ANALYSIS OF HYDRODYNAMIC  
CONTROL, HRI, INC.  
CROWNPOINT AND CHURCHROCK  
NEW MEXICO URANIUM MINES

October 7, 1993

Q4/98. COMMENT: Potential for Excursions at Church Rock Site.

**Figure 50-2**

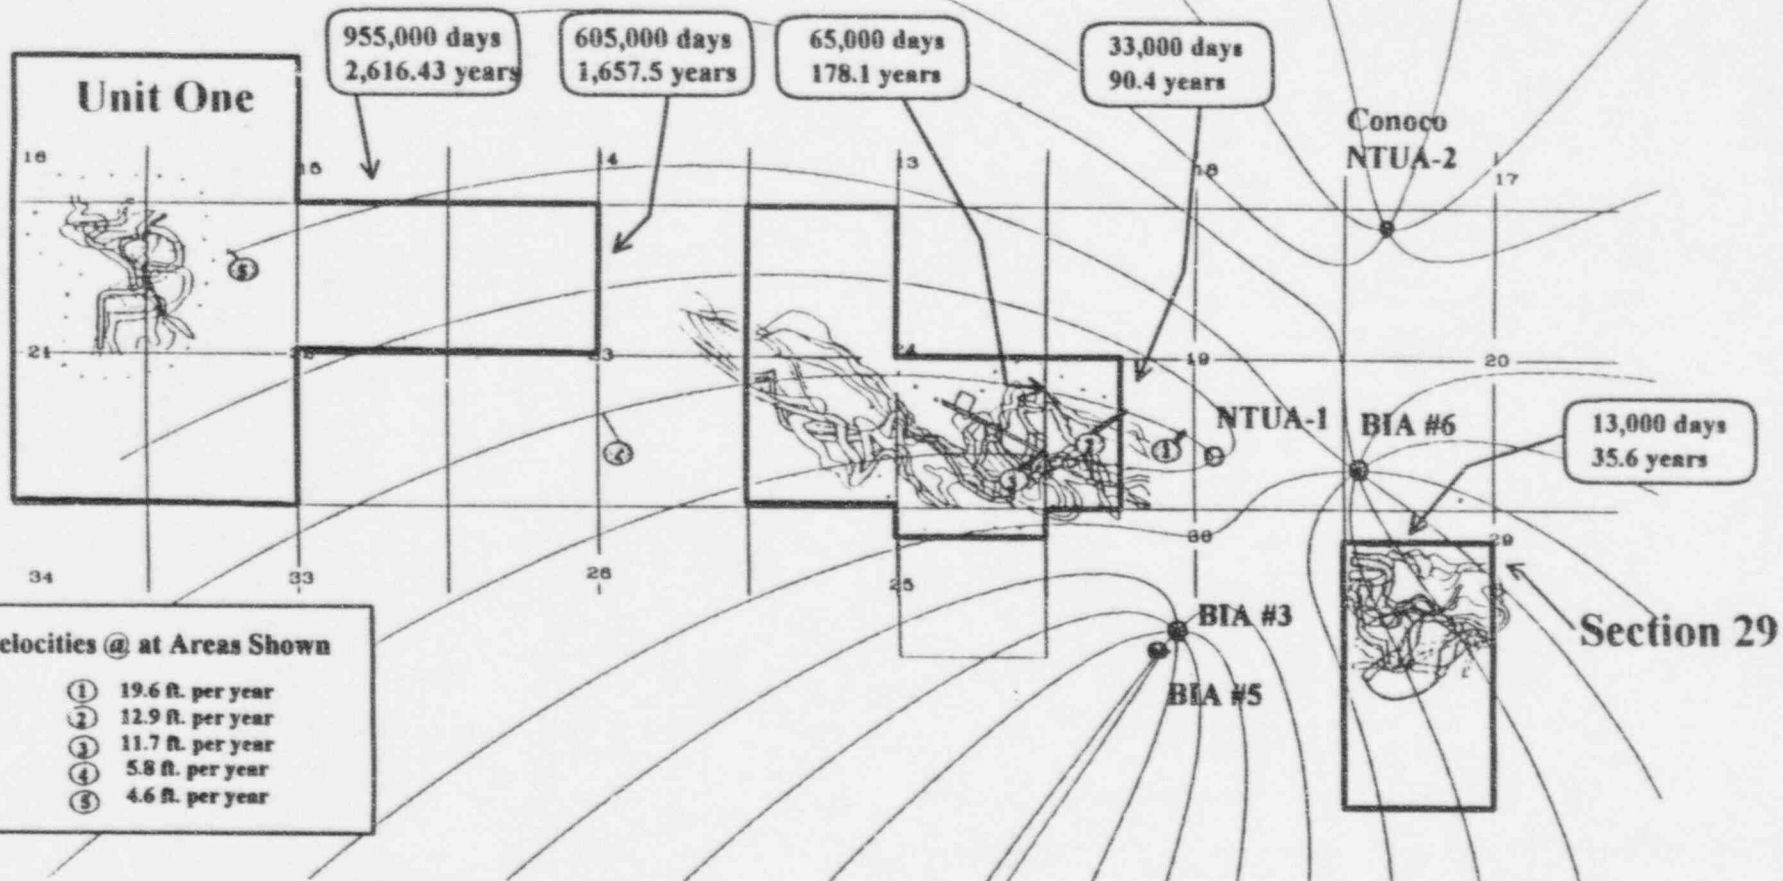
The NRC also recommended that *"prior to the injection of lixiviant at the Unit 1 site: that bonding be provided to cover the cost of town well replacement."* Since bonding is a common way to assure that monies will be available to perform and complete some important future task, HRI is not opposed to the concept of bonding itself. However, HRI is extremely concerned that such bonding might imply even the remotest, reasonable possibility that a lixiviant excursion from HRI's ISL operations at Unit 1 might reach the Town of Crownpoint water wells, a water travel-time distance away of 1000-2000 years.
